MEMORANDUM: TECHNICAL REVIEW FOR COMMERCIAL VEHICLE SAFETY CENTRE TIA	
To	Catherine Absil-Couzins
From	Tim Segedin
Date	5/01/2023
Address	253 Mill Road, Bombay, Auckland.

Edin has been asked by Auckland Transport to provide feedback on the construction of a commercial vehicle safety centre (CVSC) at 253 Mill Road, Bombay, Auckland.

Figure 1: Site Plan (Source: Traffic Impact Assessment)

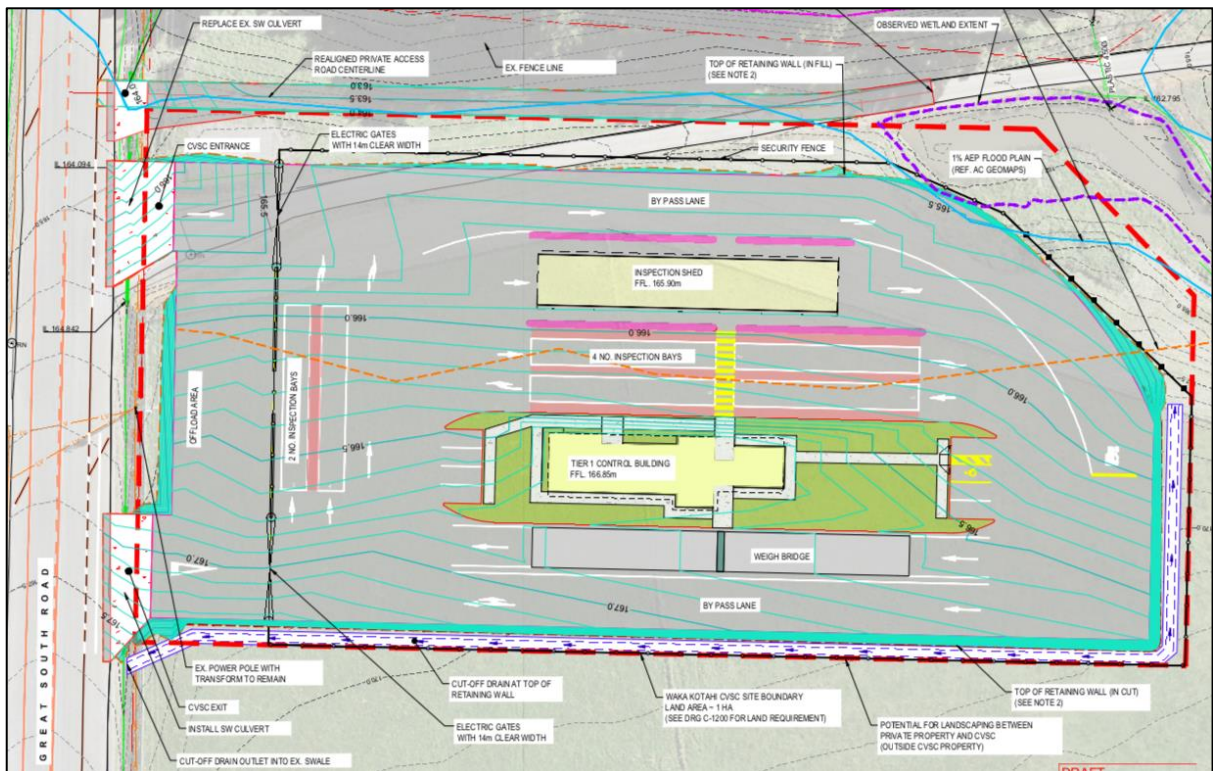
The proposed entrance only vehicle crossing is 12m wide and the proposed exit only vehicle crossing is 14m wide at the site boundary both have nonstandard flares to the road seal.

is minimised where possible". After reviewing the tracking plans provided it can be concluded that the proposed access widths currently shown are not required.

Due to the tracking required for heavy vehicles accessing the site and the absence of pedestrian and cyclist demand wider than standard accesses can be accommodated, however AT will need to approve the final design and as stated in the TIA the vehicle crossing widths should be minimised and suitable tracking provided to illustrate this.

- Suitable street lighting should be included in the proposal to ensure good visibility of turning vehicles during night time operation.
- Access widths at the site should be minimised as part of detailed design.

Figure 2: Geomatic Design Changes (Source: Traffic Impact Assessment)

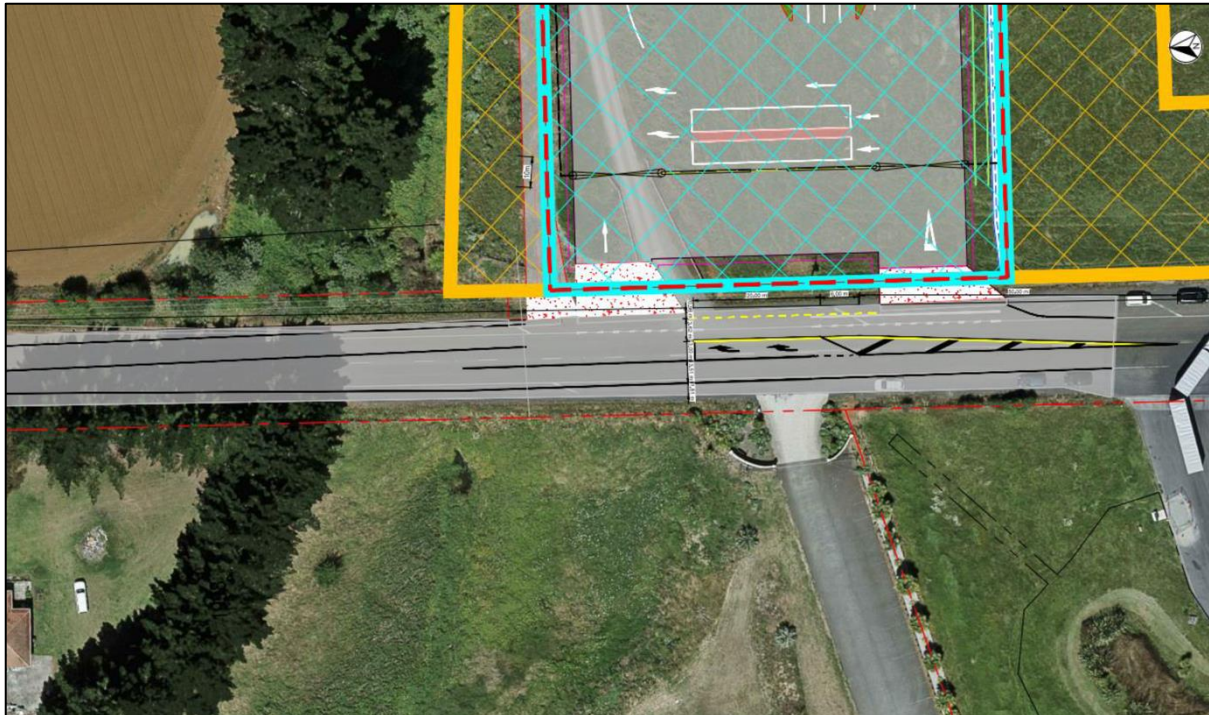
The TIA Assessment highlights that the rate of 15 trucks turning per hour and the maximum through traffic of 200 vph that a right turn bay is not required based on Austroads Guide to Traffic Management: Part 6 (2020). However, due to the increased time required for turning movements of heavy vehicles, it is considered formal provision should be made to ensure the safe uninterrupted operation of general traffic.

The final design of the turning facility needs to account for the Sikh Temple entrance, where it can be expected that vehicles will need to make a right turn manoeuvre. Therefore a section of flush median along Great South Road could be more appropriate to accommodate the existing vehicle movements entering and exiting the Sikh Temple.

- A suitable right turn facility should be included in the design for the site accesses
- Mitigation measures such as restricted operating times should be considered and outlined to address the concern of significant increased delay at the interchange off ramps, this is of particular importance for right turning vehicles at the northbound off ramp.
